ENTECH
ENGINEERING, INC.

Re: CGS Review Comments Response
Sterling Ranch East – Filing No. 6, Final Plat
El Paso County, Colorado
Entech Job No. 241419
EPC File No. SF2610

SITE AND EXPLORATION PLAN	JOB NO. 241419
	STERLING RANCH EAST FILING NO. 6 CLASSIC SRJ	
		FIG. 1

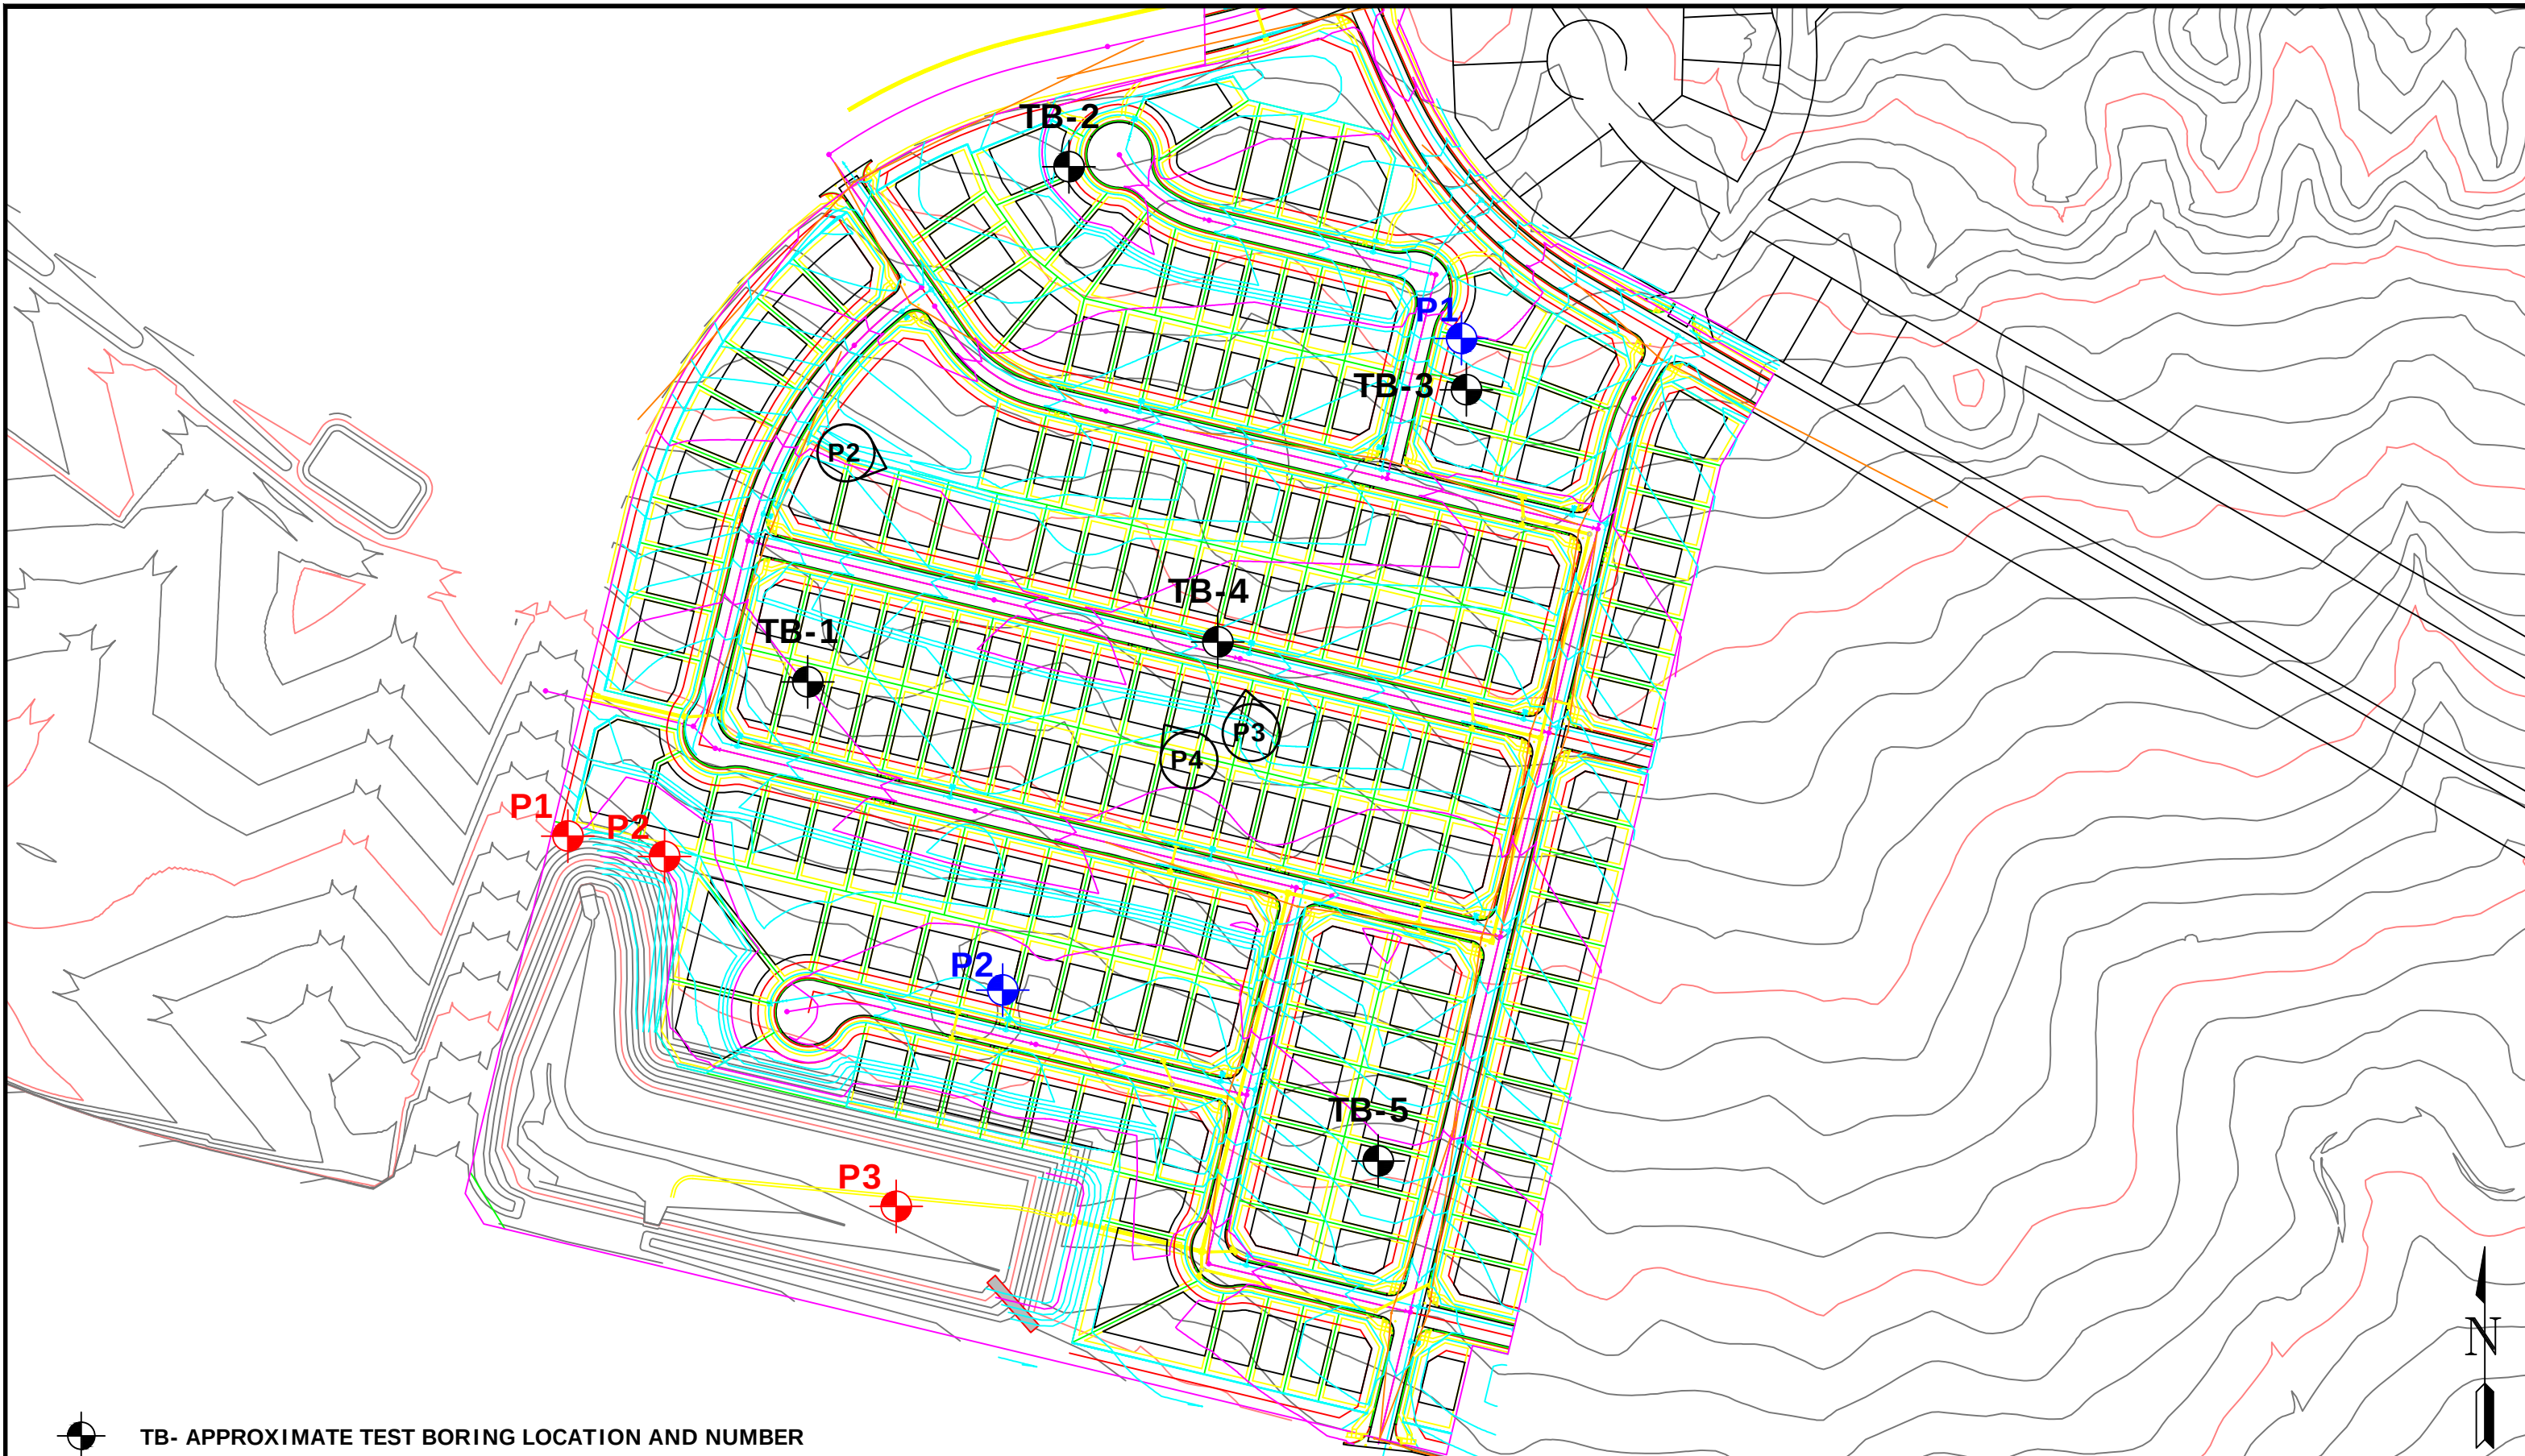
Entech Engineering, Inc. (Entech) has performed seasonal groundwater monitoring for the Sterling Ranch East Filing No. 6 subdivision. Three additional piezometers were placed in the proposed regional detention pond FSD-16 to further evaluate the groundwater levels for the area. The groundwater measurements for the piezometers within Filing 6 and the regional detention pond are shown in Exhibit 1. The approximate locations of the piezometers are shown in the Site and Exploration Plan, Figure 1.

Entech Response to Comment 1: Based on the water levels basement construction can be used on the majority of site. In areas where groundwater is encountered within 3 feet of proposed foundation grade additional drains will likely be needed. Final recommendations should be determined after additional site investigation once site grading and utility installation has been completed.
